MFN 07-479
September 4, 2007

Subject: **Submittal of ABWR Licensing Topical Report (LTR) NEDO-33372,
"Advanced Boiling Water Reactor (ABWR) Containment Analysis"**

Enclosure 1 contains the GEH LTR that reviews the Design Change Document (DCD) description of the ABWR Containment design and analyses. Engineering analysis performed subsequent to ABWR certification identified improvements in the analysis assumptions regarding feedwater flow, decay heat and containment vent modeling that should be reflected in the certified ABWR containment analysis. The proposed changes are based on the updated ABWR containment analysis and conservative results using GE-14 fuel assumptions. This LTR describes the revised ABWR containment analysis, the results, and the proposed changes.

**Figure 3 Certified ABWR Feedwater Line Break Flow –
Feedwater System Side of Break**

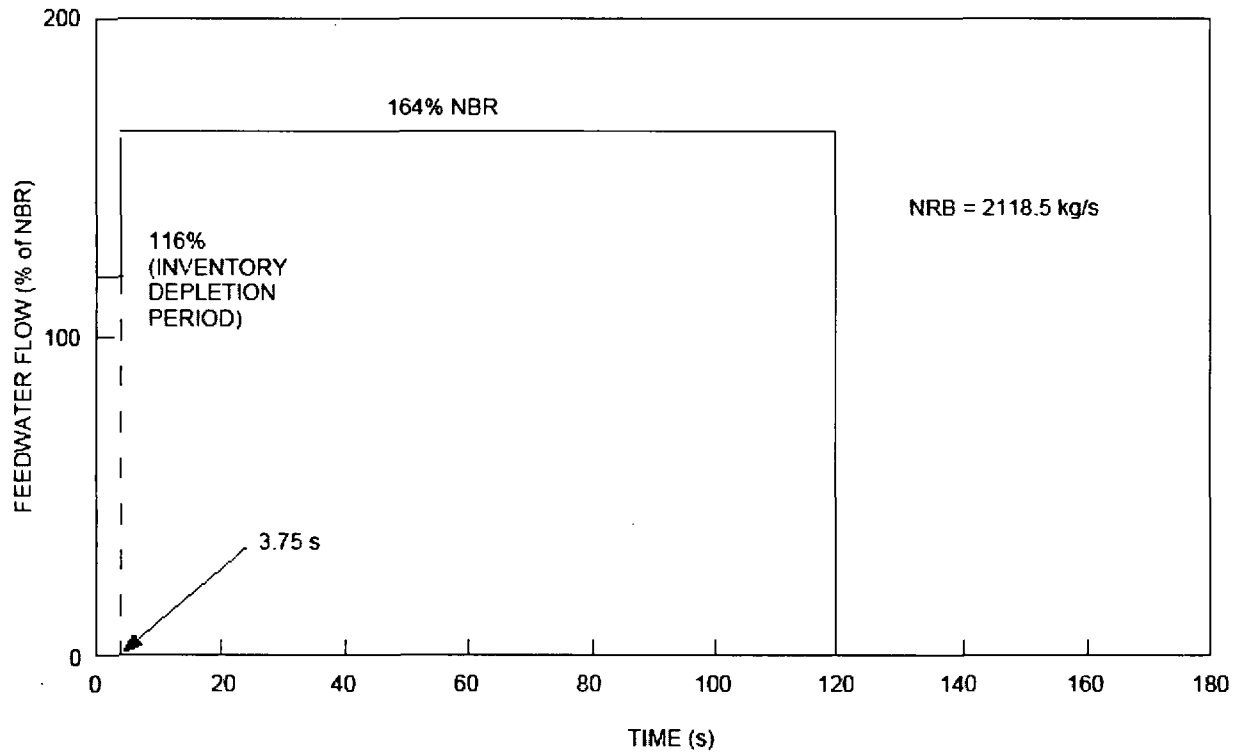
The feedwater system side of the FWLB was modeled (Figure 3) by use of a time variant feedwater mass flow rate and enthalpy directly to the drywell airspace. The time histories of the mass flow and enthalpy were determined from the operating characteristics of anticipated feedwater system performance.

The maximum possible feedwater flow rate was calculated to be 164% of nuclear boiler rated (NBR) flow, based on the response of the feedwater pumps to an instantaneous loss of discharge pressure. Since the Feedwater Control System would respond to the decreasing reactor pressure vessel (RPV) water level by demanding increased feedwater flow, and there was no FWLB logic/mitigation in the certified ABWR design, this maximum feedwater flow was assumed to continue for 120 seconds. This was based on the following assumptions:

**Figure 4 Revised Feedwater Line Break Flow –
Feedwater System Side of Break**

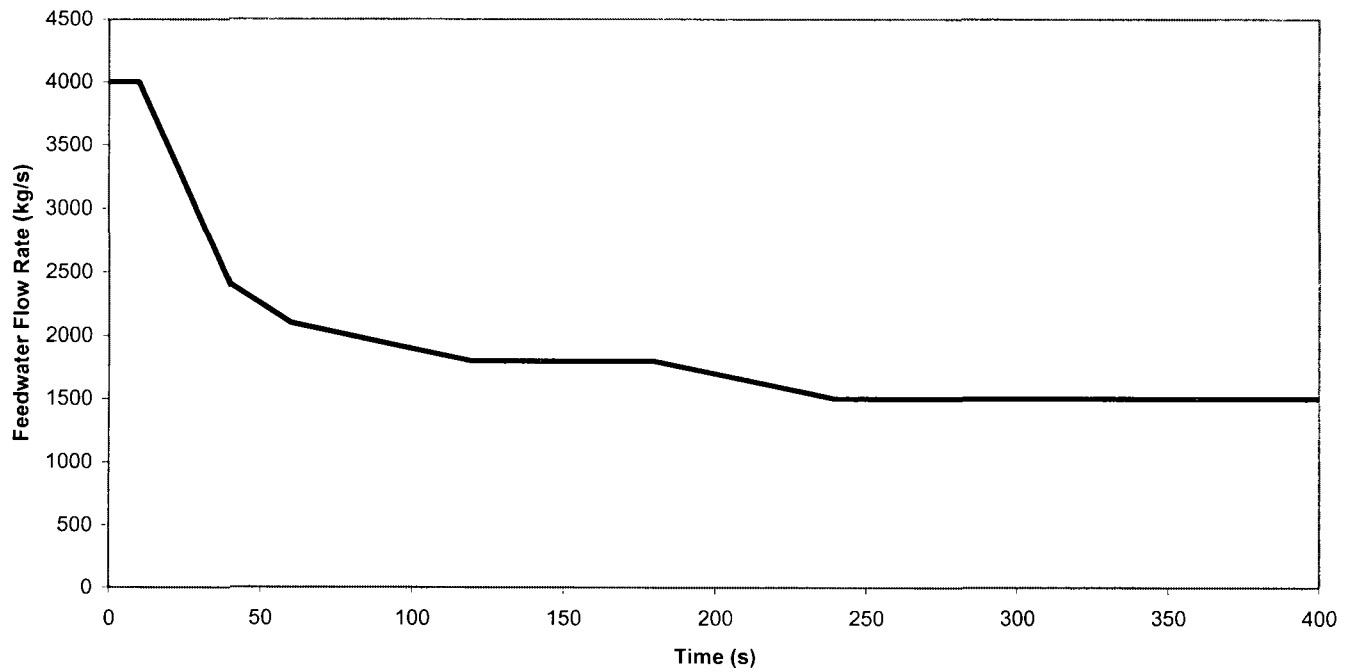
The feedwater system side of the FWLB was again modeled (Figure 4) by using a revised time variant feedwater mass flow rate and enthalpy directly to the drywell airspace. As shown in this figure, however, flow is assumed to continue until the condensate discharge and feedwater portions of the systems are drained. This eliminates the certified ABWR DCD baseline assumption of feedwater flow step changing to zero at 120 seconds. The time histories of the mass flow and enthalpy (Figure 5) were determined from the predicted characteristics of a typical feedwater system performance. The conservatism of the assumed mass flow and enthalpies will be confirmed after the detailed condensate and feedwater system designs and procurement of major equipment are completed (e.g., piping lengths and pump characteristics).

Figure 6 Feedwater Line Break Mitigation

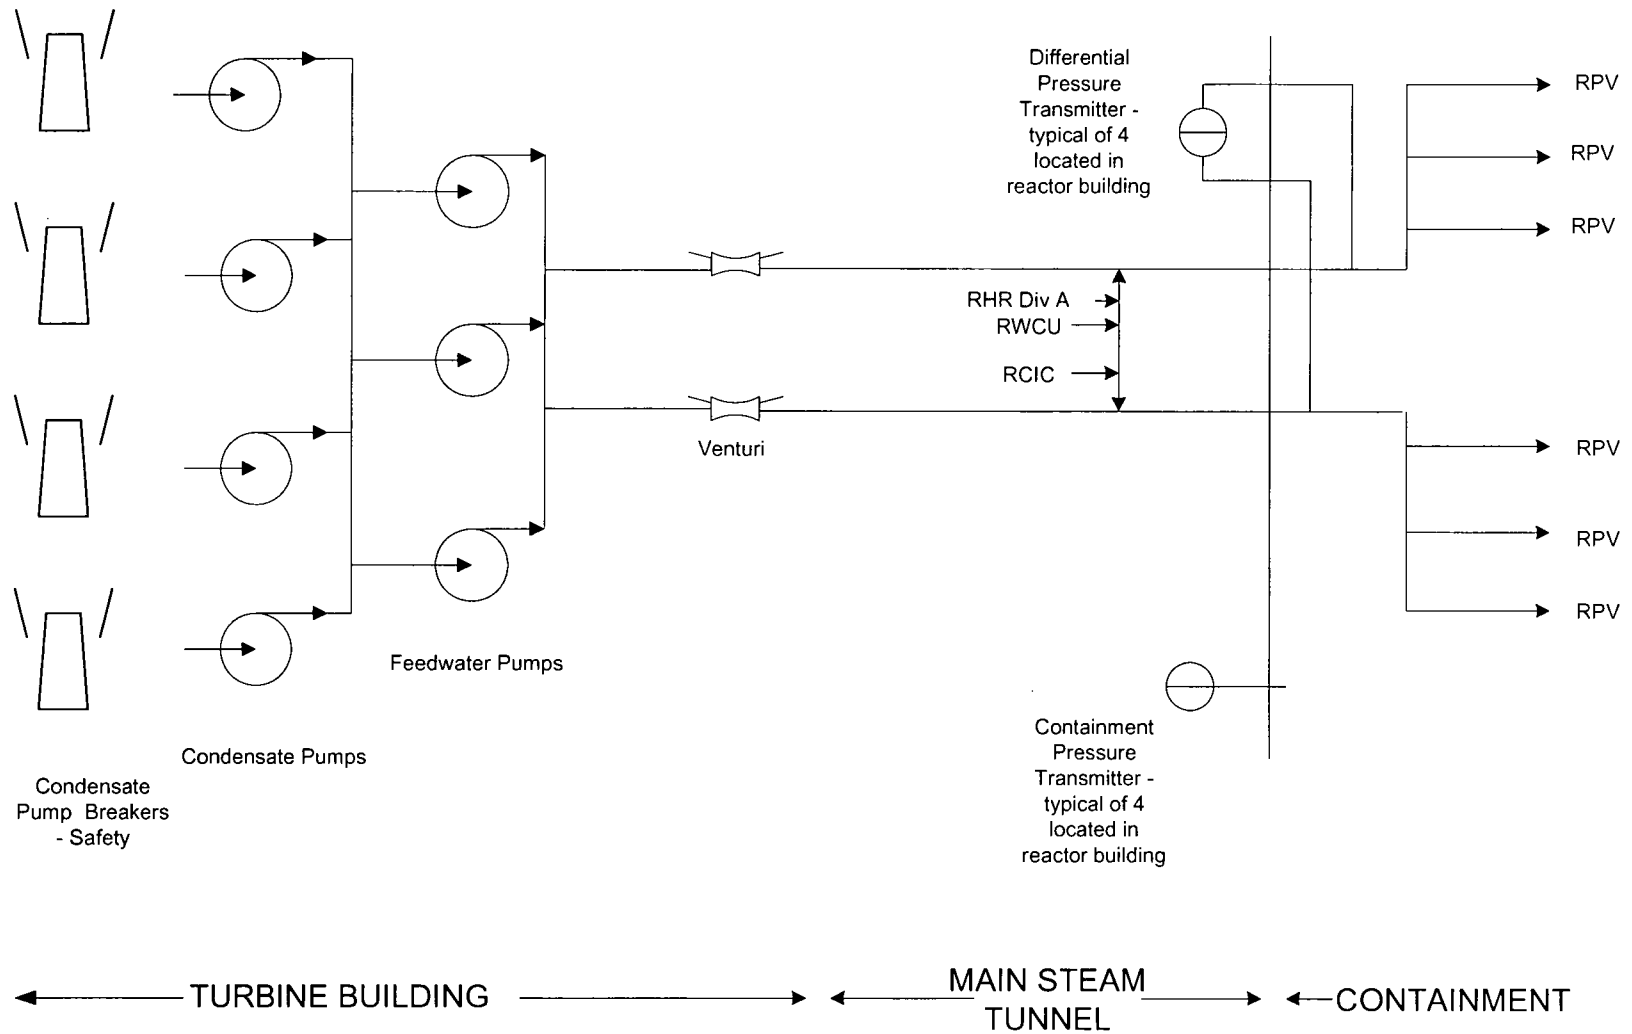
In addition, to provide added assurance of acceptable results, FWLB mitigation is added to the ABWR design. A break of the feedwater line is detected by instrumentation that measures the differential pressure between the two-feedwater lines and then confirmation of high drywell pressure will enable the logic to trip the condensate pumps (Figure 6). The logic and breakers will be safety-related to add assurance that only safety-related equipment is credited in the analysis.

**Figure 3B-13 Schematic of the Pool Swell Phenomenon**

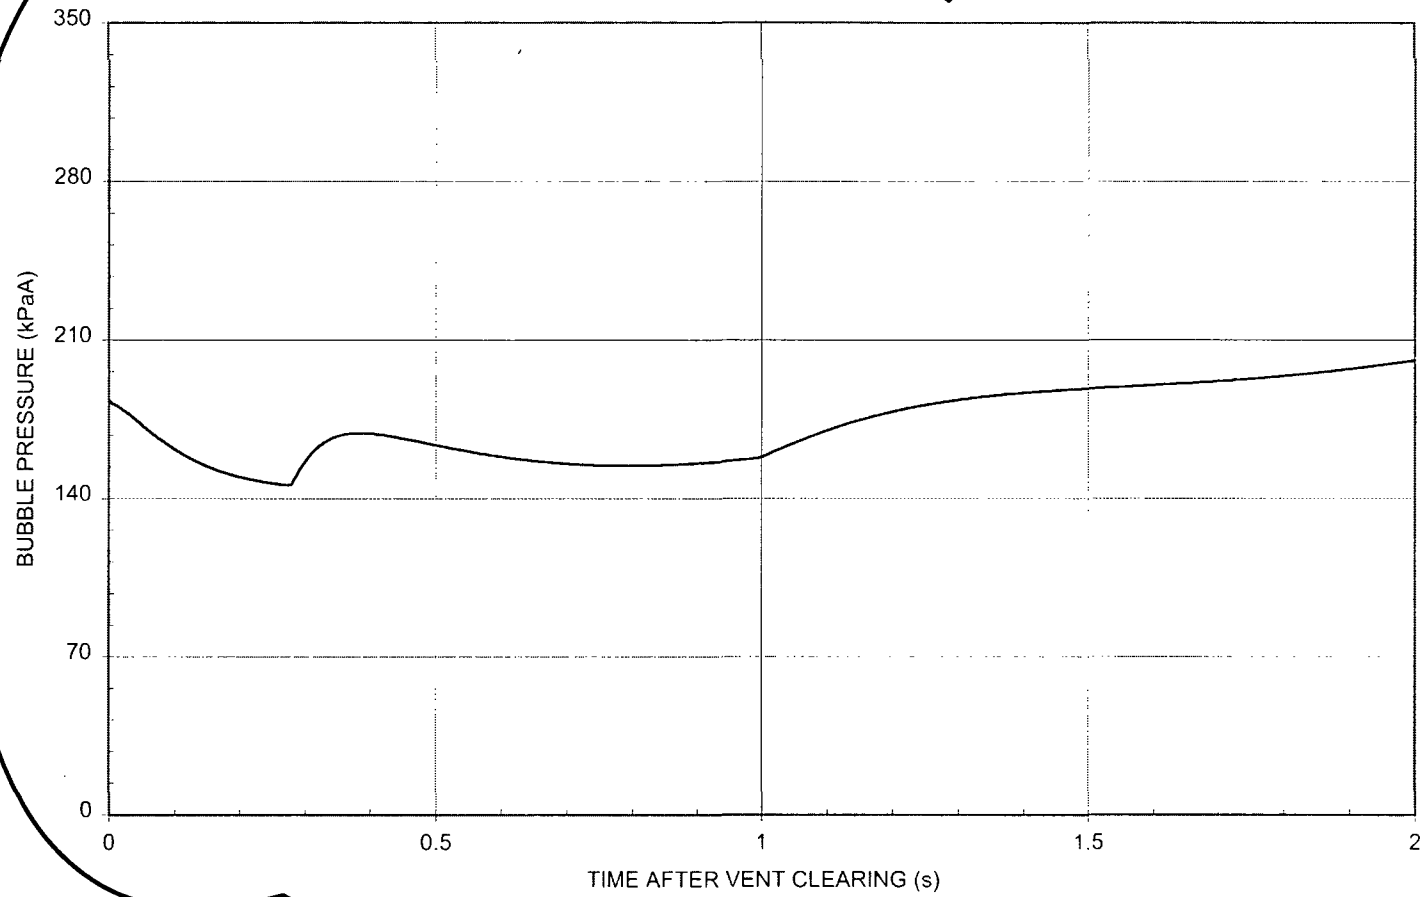
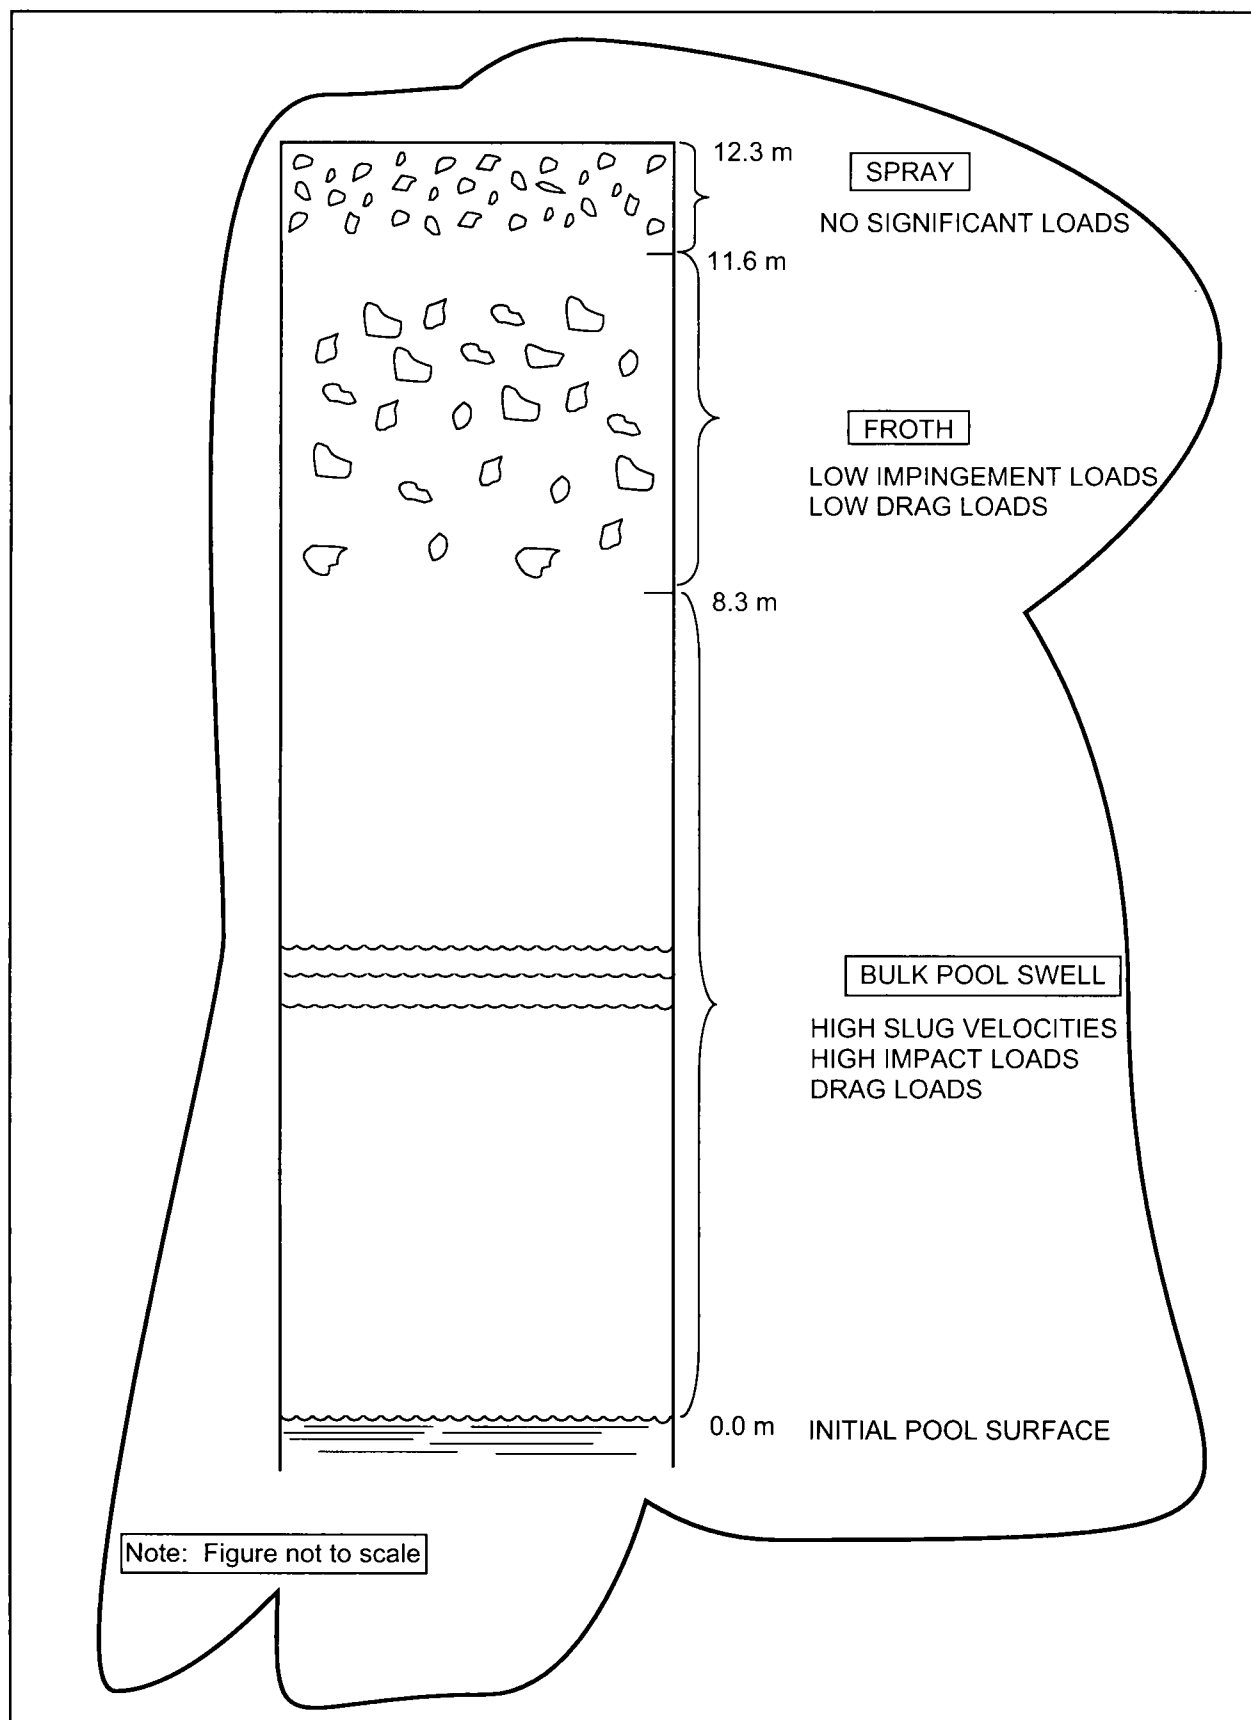
Structures located between 0 and ~~7m~~ 8.3m above the initial surface will be subjected to impact load by an intact water ligament, where the ~~7m~~ 8.3m value corresponds to the calculated maximum pool swell height. The load calculation methodology will be based on that approved for Mark II and Mark III containments (NUREG-0487 and NUREG-0978).

Structures located at elevations between ~~7m~~ 8.3m and ~~10.3m~~ 11.6m will be subjected to froth impact loading. This is based on the assumption that bubble breakthrough (i.e., where the air bubbles penetrate the rising pool surface) occurs at ~~7m~~ 8.3m height, and the resulting froth swells to a height of 3.3m. This froth swell height is the same as that defined for Mark III containment design, and this is considered to be a conservative value for the ABWR containment design. Because of substantially smaller wetwell gas space volume (about 1/5th of the Mark III design), the ABWR containment is expected to experience a froth swell height substantially lower than that in Mark III design. The wetwell gas space is compressed by the rising liquid slug during pool swell, and the resulting increase in the wetwell gas space pressure will decelerate the liquid slug before the bubble break-through process begins. The load calculation methodology will be based on that approved for the Mark III containment

As shown in Figure 3B-13 the gas space above the ~~10.3m~~ 11.6m elevation will be exposed to spray condition ~~including~~, which is expected to induce no significant loads on structures in that region.

Figure 6.2- 3 Feedwater Line Break Flow—Feedwater System Side of Break

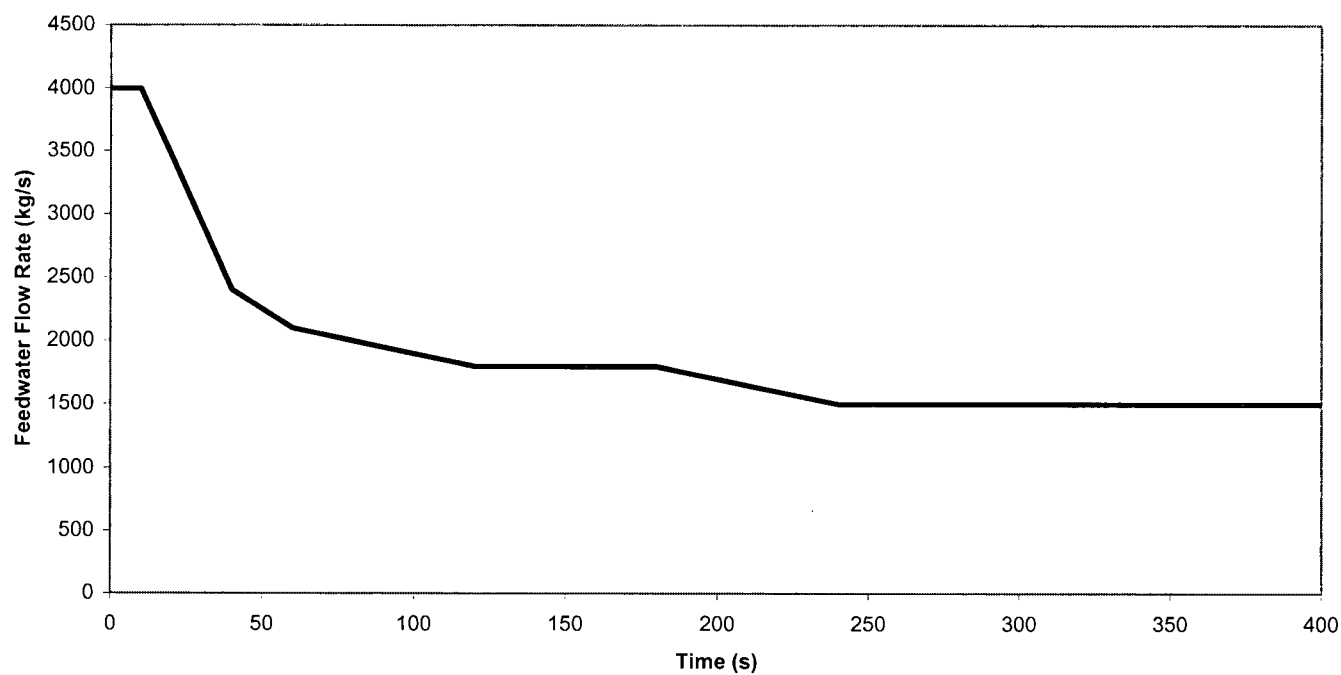
~~The maximum possible feedwater flow rate was calculated to be 164% of nuclear boiler-rated (NBR), based on the response of the feedwater pumps to an instantaneous loss of discharge pressure. Since the Feedwater Control System will respond to decreasing RPV water level by demanding increased feedwater flow, and there is no FWLB sensor in the design, this maximum feedwater flow was conservatively assumed to continue for 120 seconds (Figure 6.2-3). This is very conservative because:~~

(2) FWLB mitigation has been added to the ABWR design as described in Section 7.3.1.1.2.

Figure 6.2- 8 Temperature Time History After a Feedwater Line Break

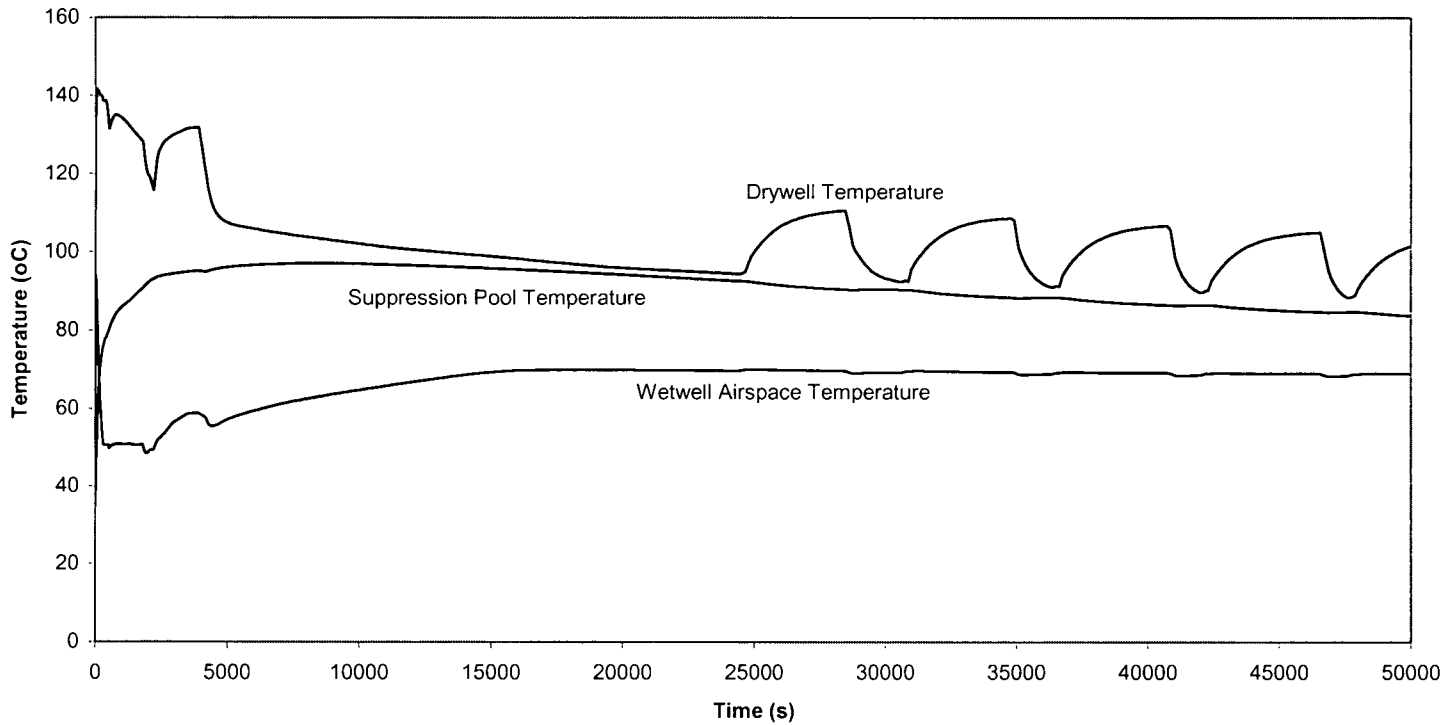
The ~~short~~ long-term pressure peak (~~268.7~~ 279.6 kPaG) of Figure 6.2-8a is the peak pressure for the whole transient. Figure 6.2-8 shows temperature time histories for the suppression pool, wetwell, and drywell temperatures. The peak pool temperature (~~96.9~~ 97.1 °C) is reached at ~~15,350~~ 8596 seconds (~~4.264~~ 2.39 hours) and remains below the 97.2°C limit.
